26 April 2018 Mr. Snow Barlow, chair, IPC Committee determining Boggabri Coal Modification 7 via email:

**Boggabri Coal Mine: Modification 7**

#### The proponent has provided inadequate information

**Biodiversity corridor**- Post 2019 clearing Aerial view 20/4/2019 (Approx 1200m between Boggarbri Mine (bottom right) and Maules Creek Mine (top left).

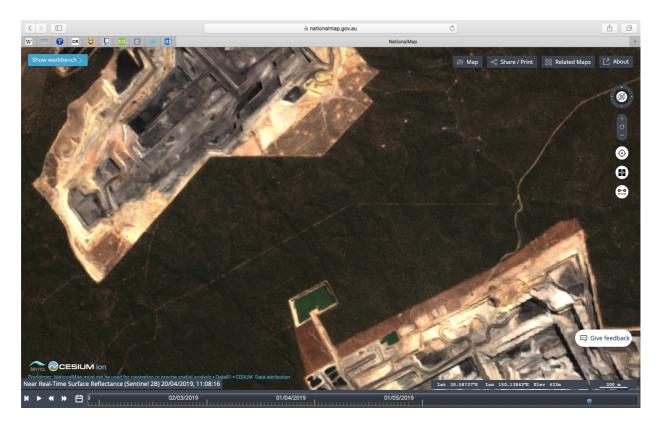
Maules Creek CWA understand that both Maules Creek Mine and Boggabri Coal would like to mine the 500 metre wide biodiversity corridor between the two mines. This is despite the intent of Boggabri Coal's Statement of Commitment ref 23 and the PA 09-0182, Schedule 2 condition 7

"The Proponent shall not clear native vegetation from any land within 250 metres of the adjoining Maules Creek Coal Mine mining lease boundary, except with the approval of the Secretary, following endorsement of OEH."

The biodiversity corridor between the two mines- Maules Creek and Boggabri is an critical part of the Commonwealth EPBC Approval and the regional strategy for fauna movement. It is high quality EPBC listed forest. It is part of the offset strategy along with rehabilitated areas to the south of Boggabri mine.

Nothing should undermine this corridor. No modification should be allowed to undermine the intent of retaining biodiversity in this location. We object to any intended or unintended consequences from a Modification that allows activities in a corridor that is not to be destroyed.

Mod 7 biodiversity, boundary change with Tarrawonga – definition of Project Approval Area- and drilling and exploration changes combine to allow the company to explore in the Native Vegetation Corridor. At the same time as delaying and changing the offsets measures. This clears the way for OEH (now part of Planning) to acquiesce to BCM's offset changes and then the Secretary to approve the newly proposed corridor location.

This corridor must stay in place. It is the proverbial canary in the coal mine for the health and recharge of the water at the heart of the Leard Forest. Please refer to Attachment 1, IESC Advice 2, 3, 4, 5, to Boggabri Coal Extension, EPBC 2009/5256, 20/12/12)
